Agenda
Village of Arlington Heights
Design Commission
Buechner Room, 1st Floor

Arlington Heights Village Hall
33 S. Arlington Heights Road
Arlington Heights, IL 60005
October 4, 2016
6:30 PM

**MINUTES OF
THE VILLAGE OF ARLINGTON HEIGHTS
DESIGN COMMISSION MEETING
HELD AT THE ARLINGTON HEIGHTS MUNICIPAL BUILDING
33 S. ARLINGTON HEIGHTS RD.
SEPTEMBER 20, 2016**

DC Number: 16-101
Petitioner Name: Irfan Patel
Petitioner Address: 102 W. Northwest Highway
Arlington Heights, IL 60005
Meeting Date: September 20, 2016
Revised Meeting Date (continued): October 4, 2016

PENCO ASSOCIATES
LANDSCAPE DESIGN PLAN

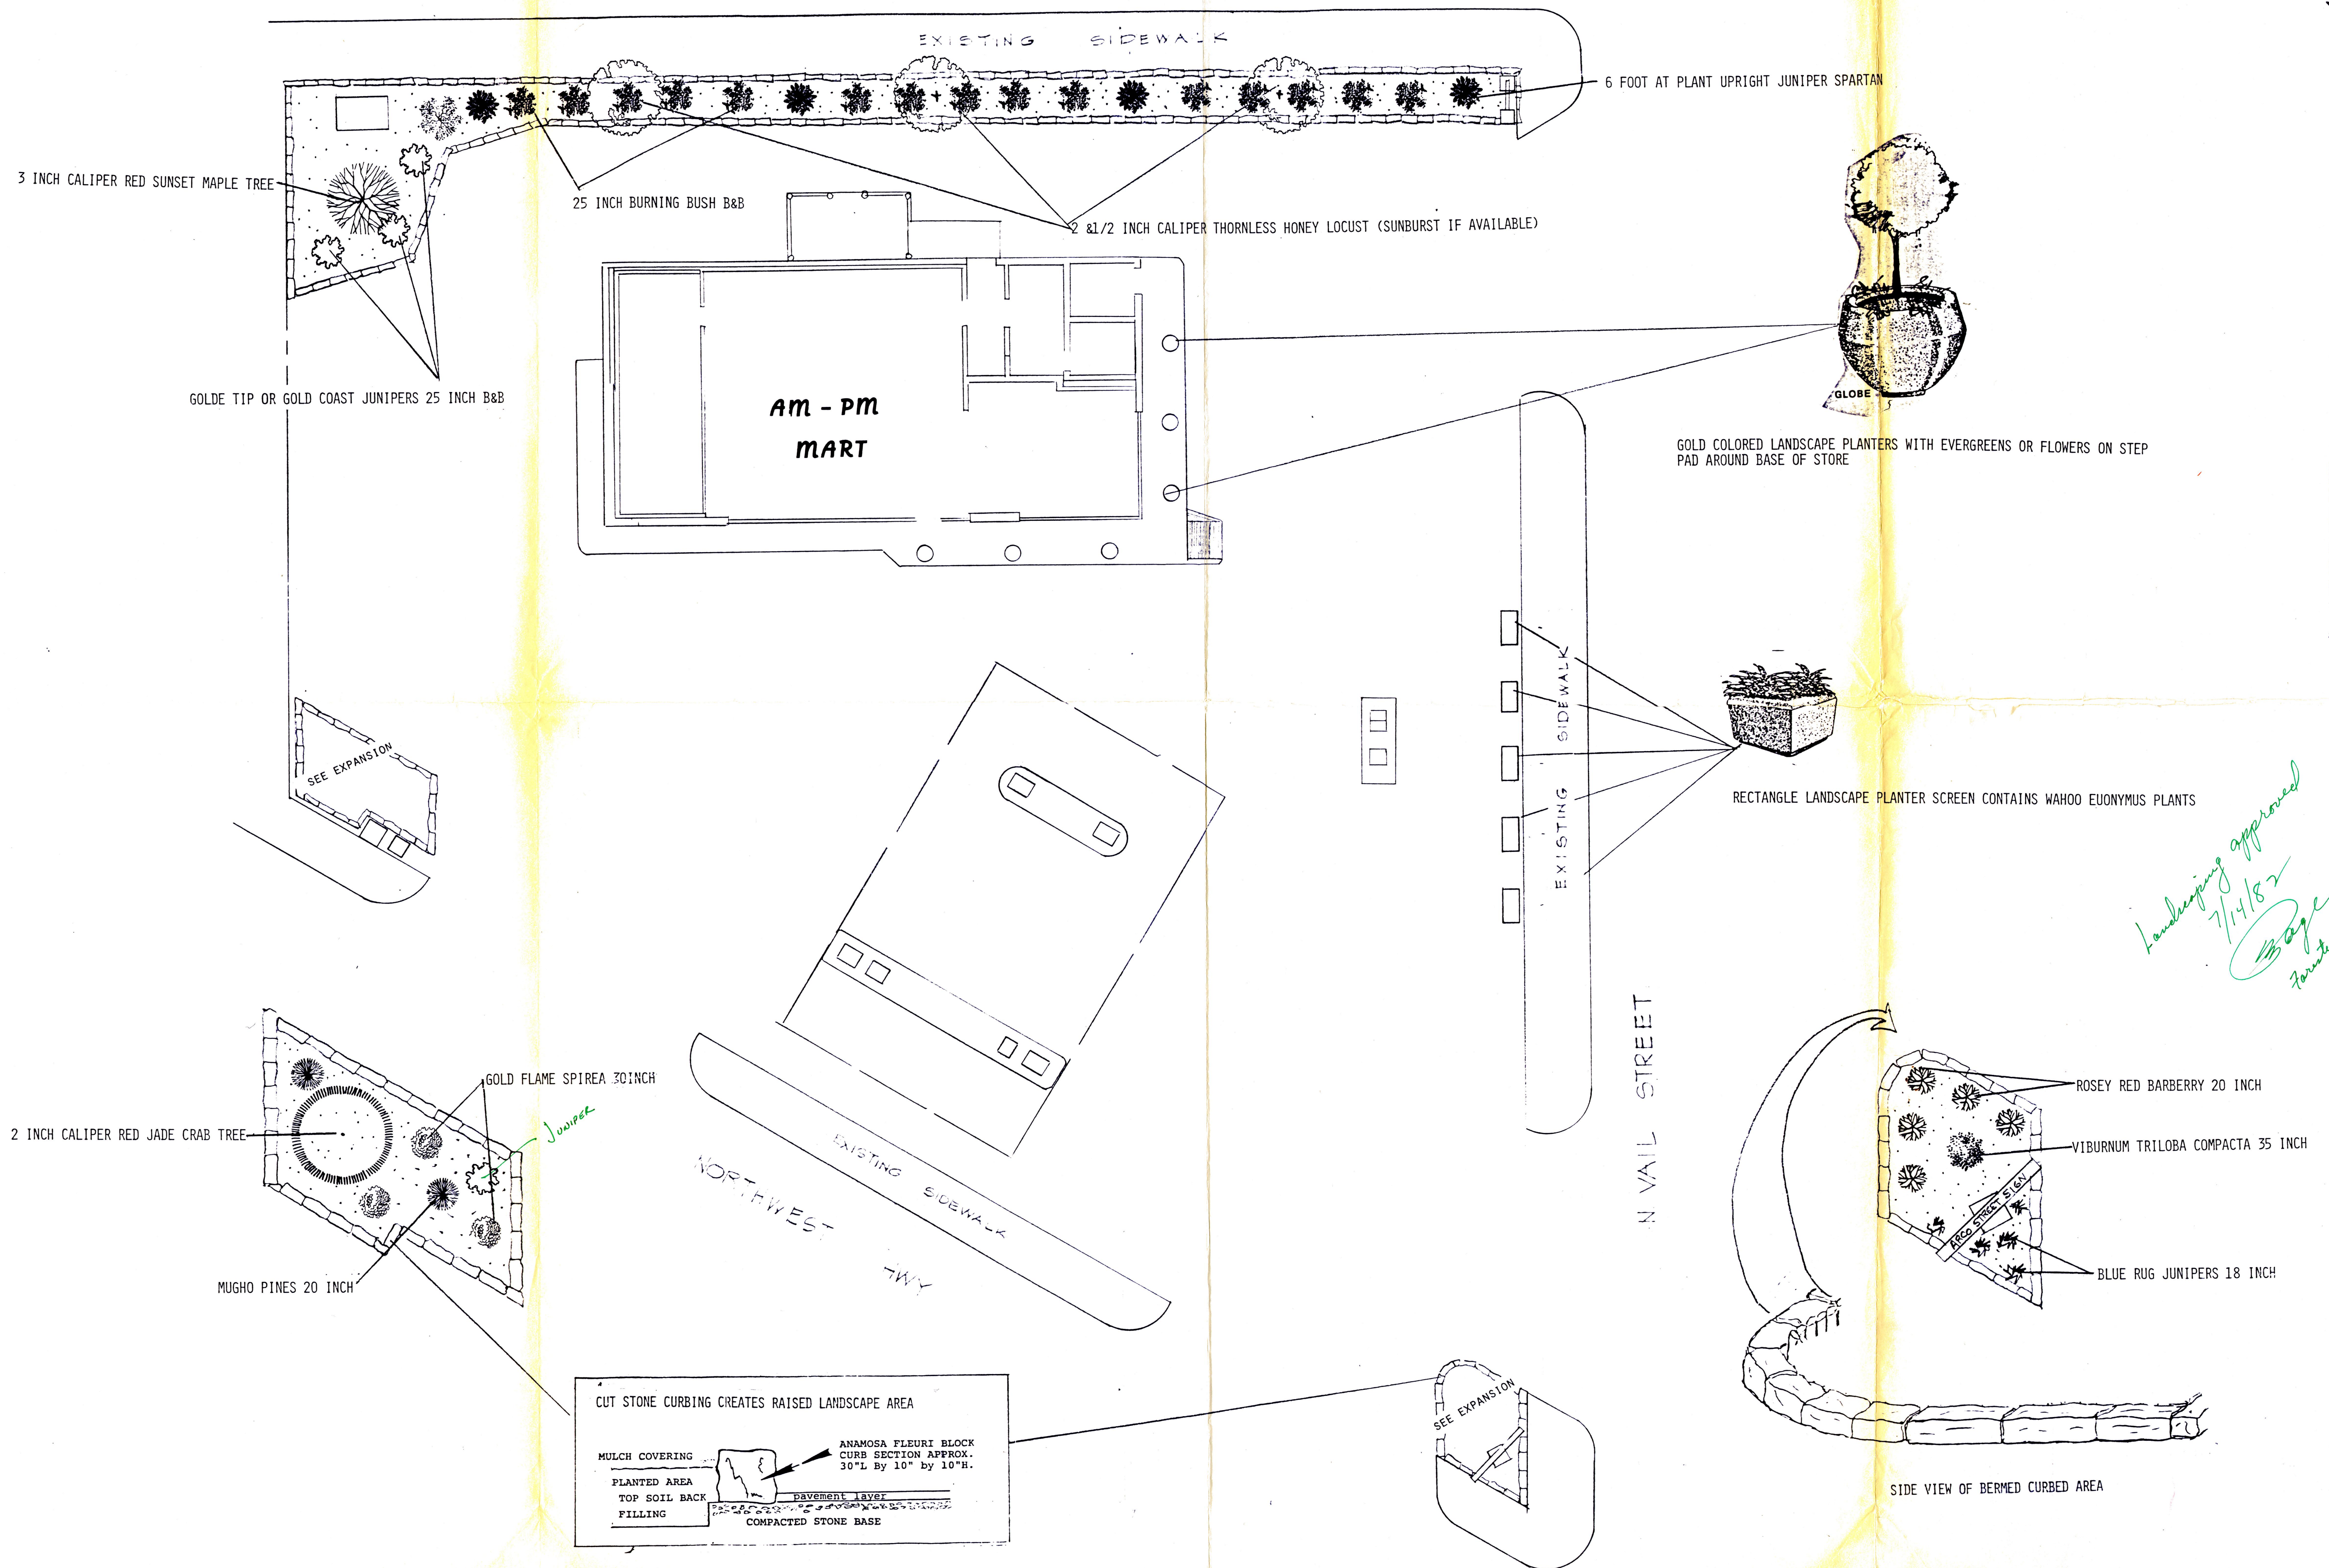
The landscaping is required to comply with the originally approved landscape plan from 1982 which includes a continuous row of 6 foot tall landscaping along the north property line to screen the back of the building. Currently, some of the landscaping in that area is either missing or dead. The dead landscaping needs to be replaced, and the voids need to be infilled. Please note, the landscaping within the easternmost 12 feet of this bed needs to be limited to 18 inches in height to maintain visibility at the street intersection.

The landscape planting bed at the southwest corner of the site is in poor condition and needs to be improved. The edge of the bed should be improved with new curb or landscape blocks, and the landscape plantings should be trimmed, replaced, and infilled as needed.

5. Replace dead landscaping and infill voids to provide continuous 6 foot tall landscaping in the bed along the north property line. The plantings shall be limited to 18 inches in height within 12 feet of the street intersection.

6. Improve the existing landscape planter at the southwest corner of the site with new curbs or landscape blocks and trim, replace, infill the plantings as required.
